CHRYSLER A670 (31TH) AND A604 (41TE) NEW DESIGN FINAL DRIVE CROSS SHAFT RETAINERS

Figure 1

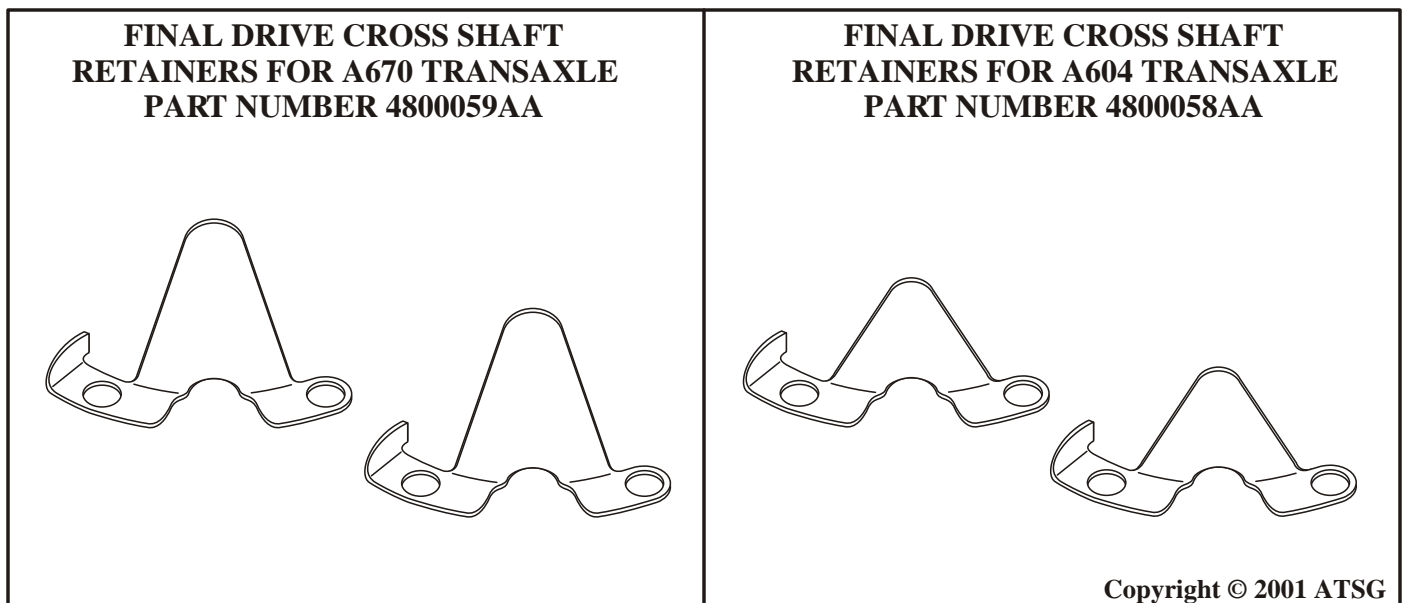
CHANGE: Beginning in the model year 2000, as a running change, Chrysler introduced a new design final drive cross shaft retainer and eliminated the retaining pin. The new design retainers are held in place by two of the ring gear retaining bolts (See Figure 1).

REASON: Eliminates the possibility of the cross shaft coming out and breaking the case.

Figure 2

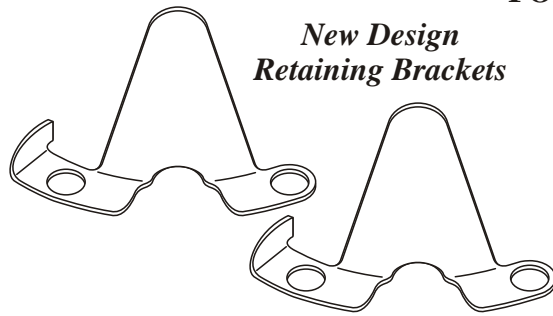
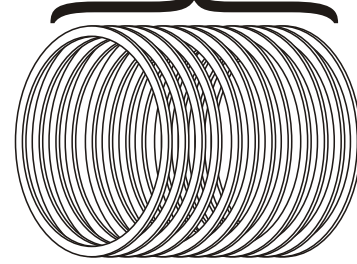
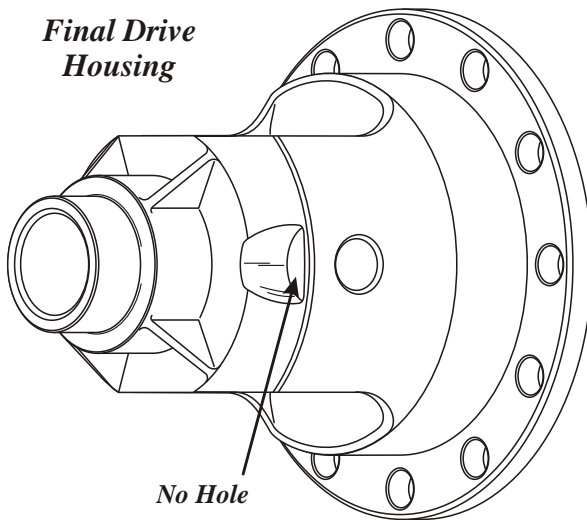
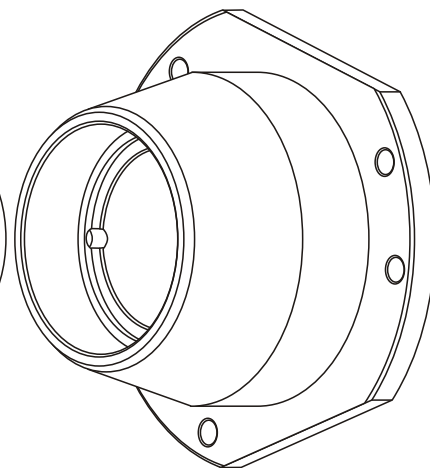
- (1) FINAL DRIVE HOUSING - Retaining pin hole eliminated (See Figure 2).
- (2) CROSS SHAFT - Retaining pin hole eliminated (See Figure 2).
- (3) CROSS SHAFT RETAINER - New design cross shaft retainer to replace the previous design retaining pin (See Figure 2).

Chrysler has now made available two service packages to back service previous design levels, one kit for the 31TH and one kit for the 41TE transaxles. The contents of these kits are illustrated in Figure 2 and part numbers are listed below under "Service Information".

Figure 3

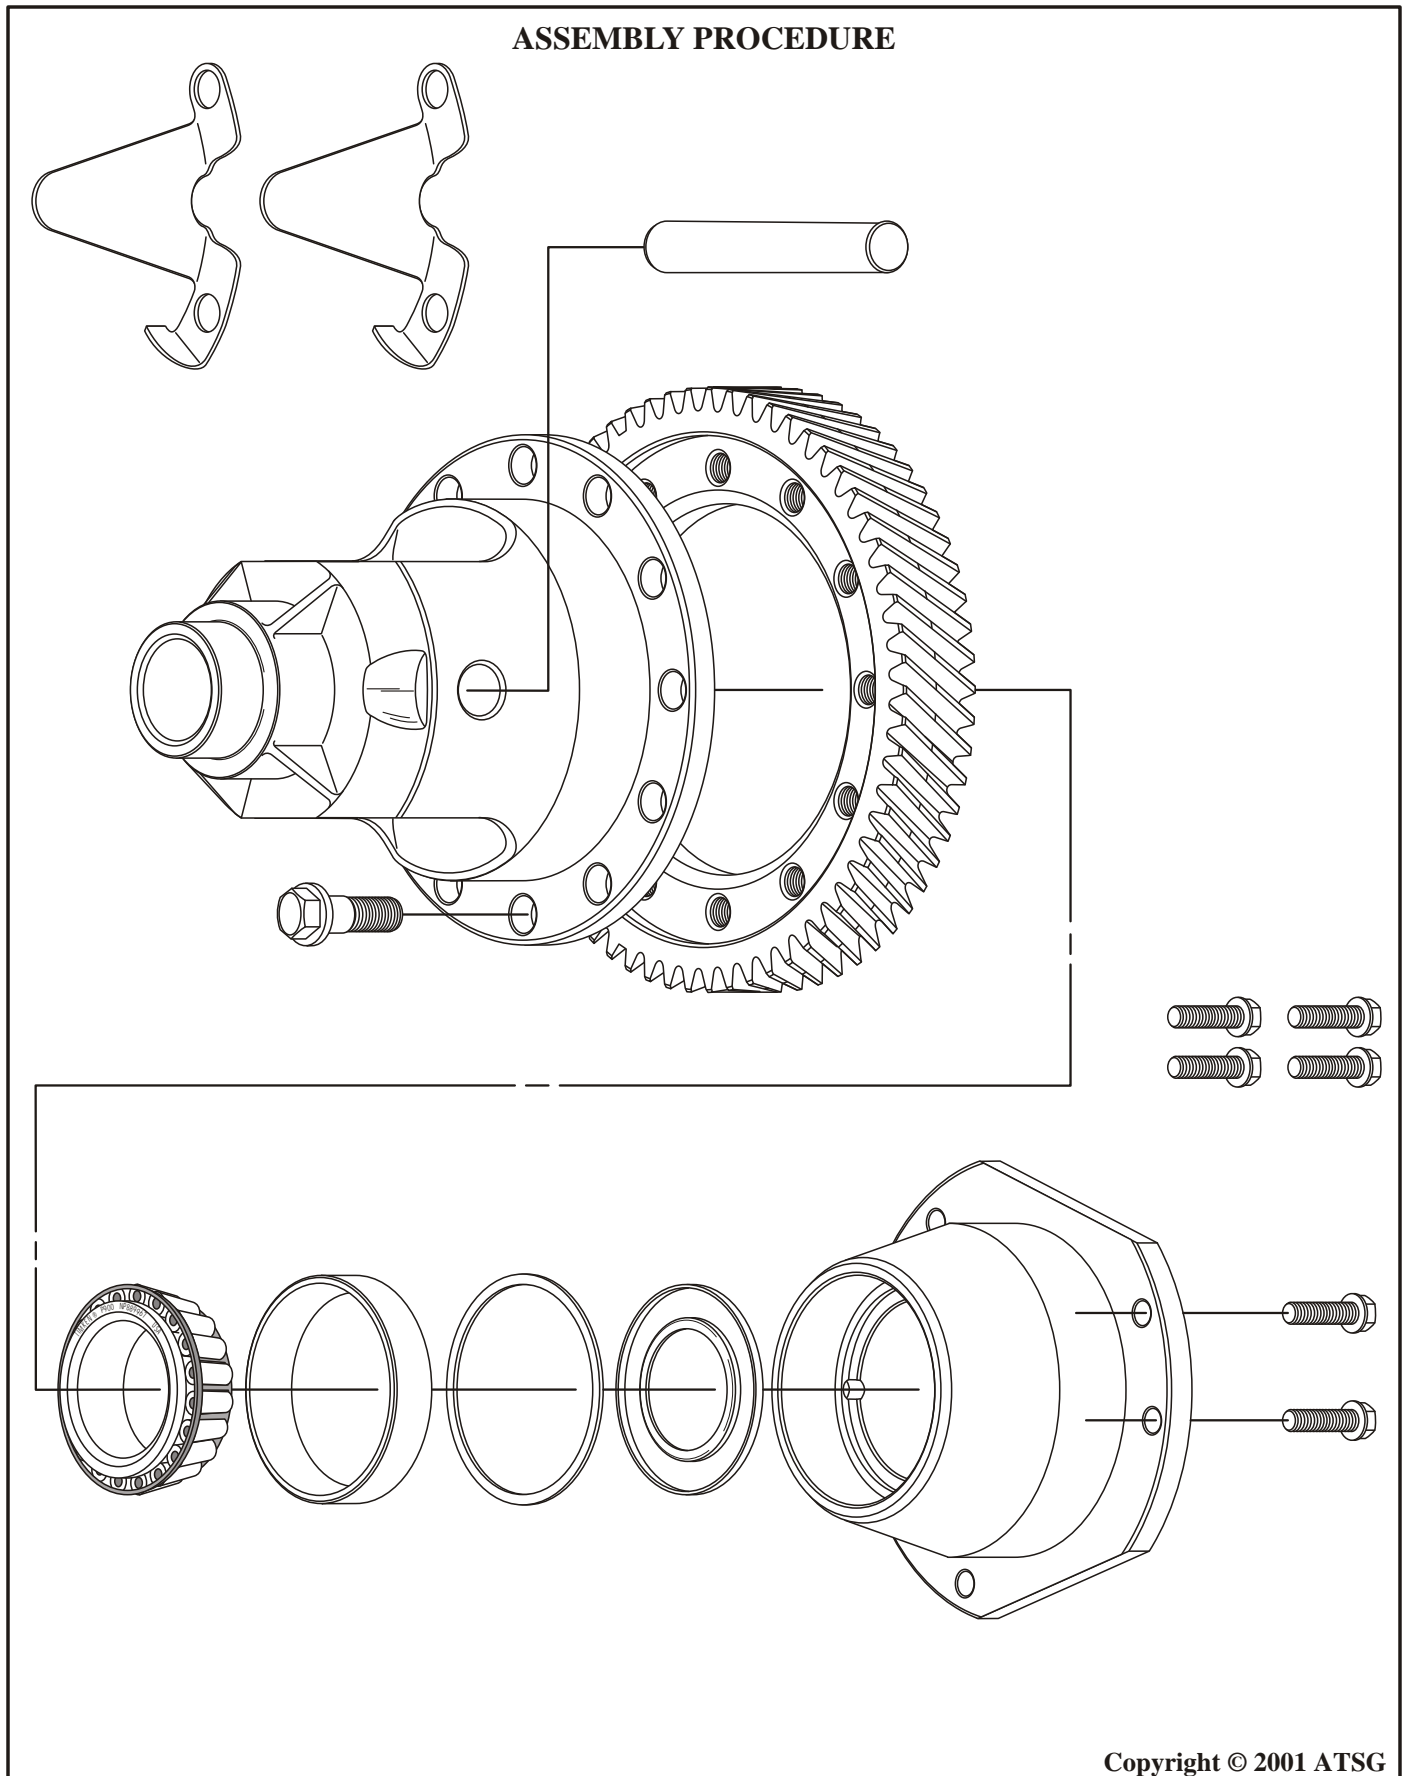
The new design retainers are also available individually from the OEM, and are installed as shown in Figures 3 and 4.
